Intersection ID: 24124	Main Street: DEHAVILLAND_DR	Cross Street: PILCHER_DR	Location:	SW
ADA ID: 40EC04B6105F	Ramp Type: PerpDiag	Initial Pass/Fail: Fail	Overall Compliance: No	Severity Score: 12.5

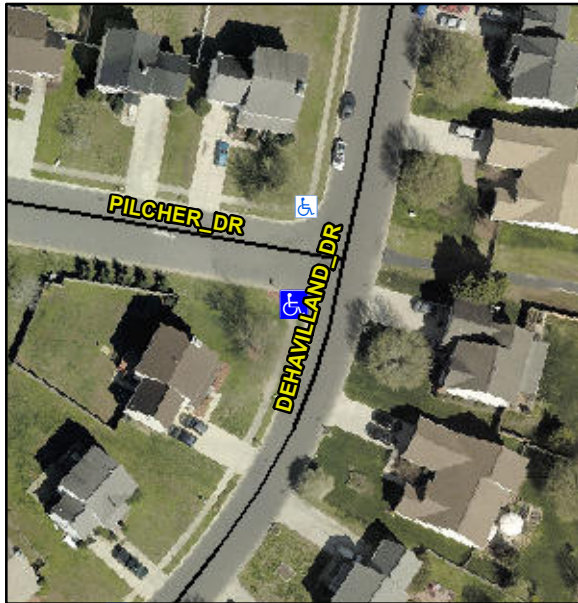
Codes/Mitigation Info/Possible Solution	Field Measurements/Component Compliance
---	---

Compliance	Description	Data	Compliance	Description	Data
N/A	Ramp Length (in)	89.0	No	Ramp Slope (%)	9.5
Yes	Ramp Width (in)	65.0	Yes	Ramp XSlope (%)	0.4
N/A	Flare Type LT	N/A	N/A	Flare Type RT	N/A
N/A	Flare Slope LT (%)	N/A	N/A	Flare Slope RT (%)	N/A
N/A	Flare Traversable LT?	N/A	N/A	Flare Traversable RT?	N/A
N/A	Landing Length (in)	N/A	N/A	DWS Provided?	N/A
N/A	Landing Width (in)	N/A	N/A	DWS Contrast?	N/A
N/A	Landing Slope (%)	N/A	N/A	DWS Length (in)	N/A
N/A	Landing X Slope (%)	N/A	N/A	DWS Full Width?	N/A
N/A	Landing Curb? (Y/N)	N/A	N/A	DWS Offset (in)	N/A
N/A	Shared Landing?	N/A			
N/A	Gutter Ponding?	N/A	N/A	Gutter Slope (%)	N/A
N/A	Gutter Lip Ht (in)	N/A	N/A	Gutter X Slope (%)	N/A
N/A	Painted X Walk1?	No	N/A	Painted X Walk2?	No
	X Walk 1 Direction	To SE		X Walk 2 Direction	To NE
N/A	X Walk 1 Width (in)	N/A	N/A	X Walk 2 Width (in)	N/A
	X Walk 1 Slope (%)	2.6		X Walk 2 Slope (%)	0.6
	X Walk 1 X Slope (%)	0.6		X Walk 2 X Slope (%)	0.6

Remove & Replace Curb Ramp With Two New Directional Ramps or Equivalent.

R304.2.2
